Product Change Notification / JAON-21NAGG091

CCB 3007.003 Initial Notice: Qualification of MPHL as an additional final test site for selected Atmel ATSAMR21G16A, ATSAMR21G17A, and ATSAMR21G18A device families available in 48L VQFN (7x7x1mm) package.

CCB 3007.003
Pre and Post Change Summary
PCN# JAON-21NAGG091

PCN #: JAON-21NAGG091

Pre and Post Change Summary

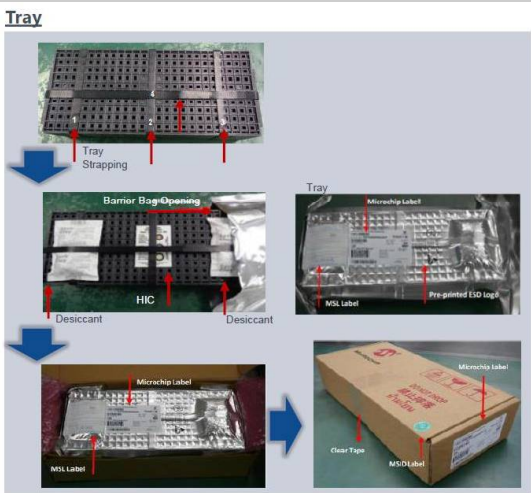
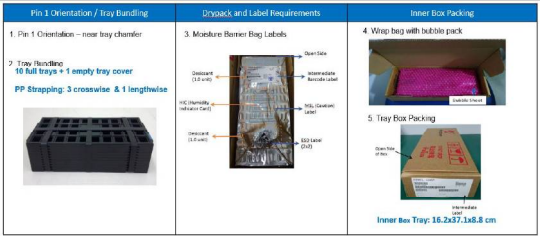
Pre Change / ATP7	Post Change /MPHL
Moisture Barrier Bag Dimension	Tape and Reel	MOISTURE BARRIER BAG (18in x 18in) 	MBB (406mm x 457 mm) 
	Tray	MBB 10" X 20" 7.0 MILS W/ ESD LOGO PRINT 	MBB (228mm x 483mm)
